STATE OF NORTH CAROLINA
DEPARTMENT OF TRANSPORTATION

Subject: **Additional Information Request for Section 401 Modification** for US 1 Vass Bypass, Moore/Lee County; TIP No. R-0210WM; Federal Aid No. NHS-1 (108); State Project No. 6.569005T; Division 8; WBS 34330.4.3.

METRIC	PROJECT REFERENCE NO.	SHEET NO.
	R-02101W	9
	R-0210A	16
	ROADWAY DESIGN ENGINEER	HYDRAULICS ENGINEER
CONST. REV.		
R/W REV.

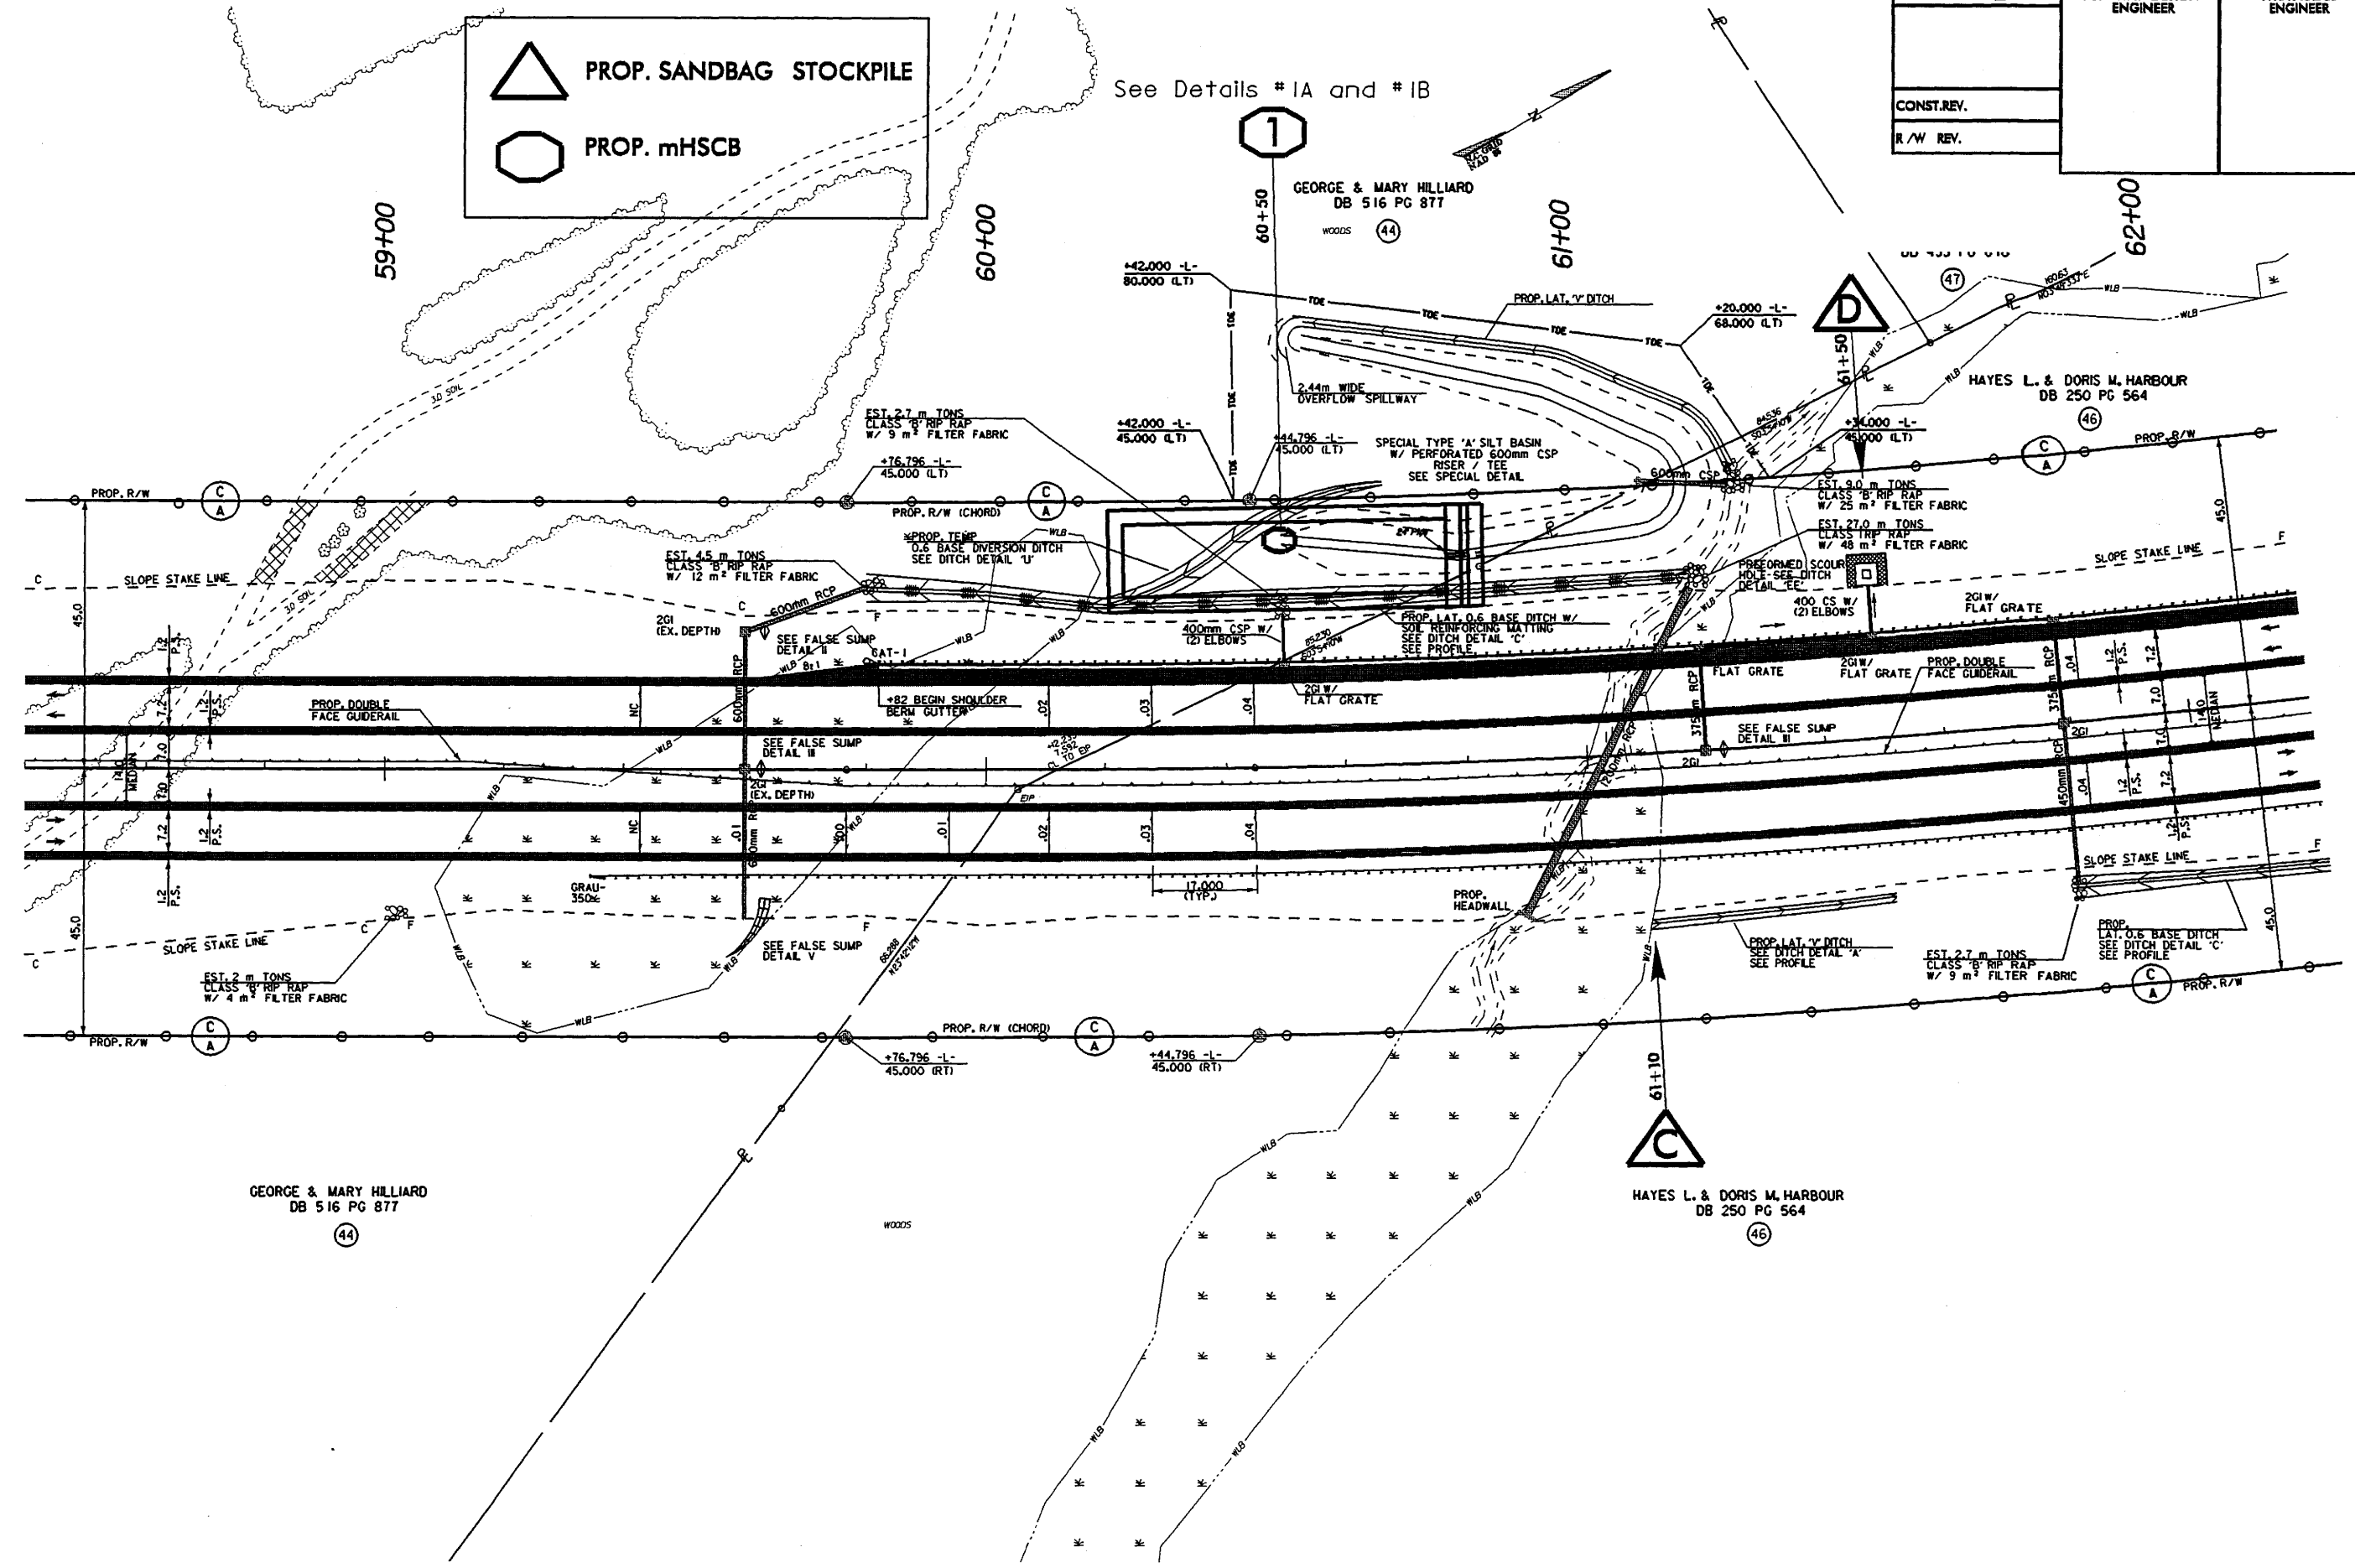
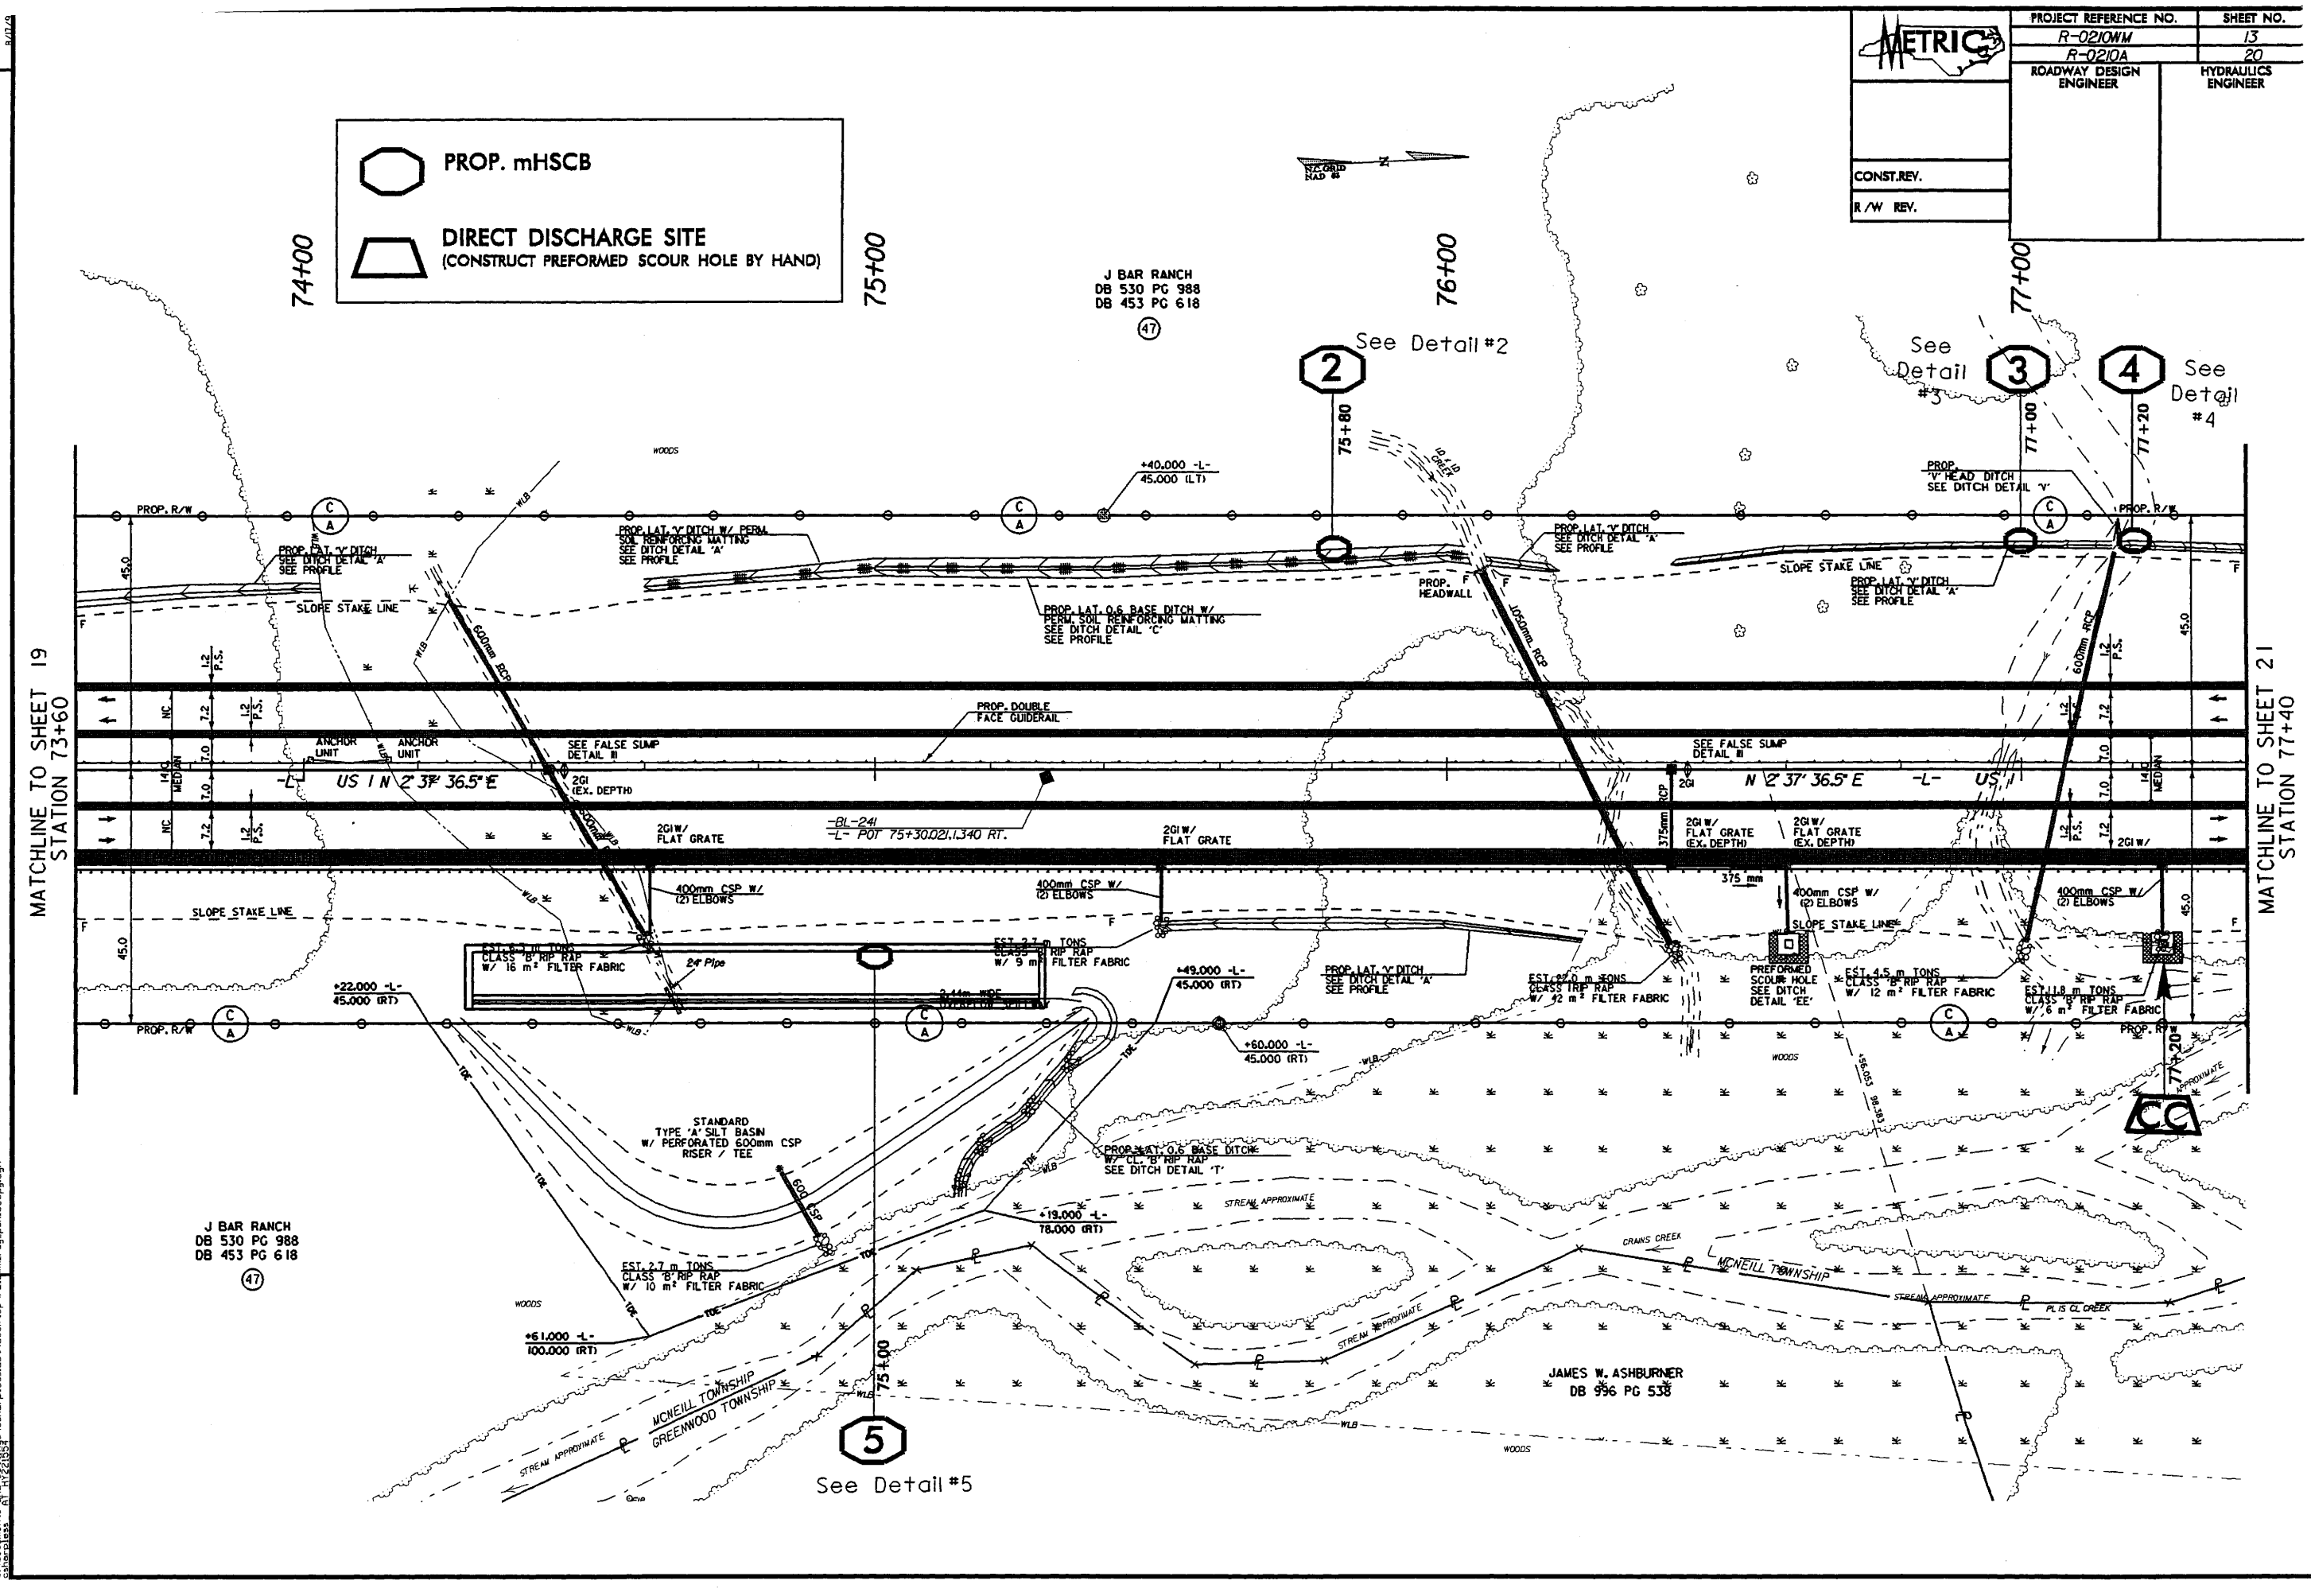
NCDWQ Comment: NCDOT describes the structures to be installed in the narrative and provides typicals for the planned structures, but does not show the structures on the plan drawings. Please provide to scale drawings of the structures on the plans showing the fill and excavation limits in relation to the existing facility, stormwater management structures, and jurisdictional waters.

Attached are revised copies of plan sheets 9 & 13 that show excavated basins 1 & 5, respectively. At all other locations the construction limits are so small the scale on the sheets renders them not distinguishable. Therefore, Detail Sheets 26-38 are provided. It should be noted that on sheet 13, site CC, is a Preformed Scour Hole and the Standard Symbol is shown to assist the reviewer in locating the site and does not represent the "to scale" construction limits on the plan sheet scale of 1" = 26.67 meters.

See Details # 1A and # 1B
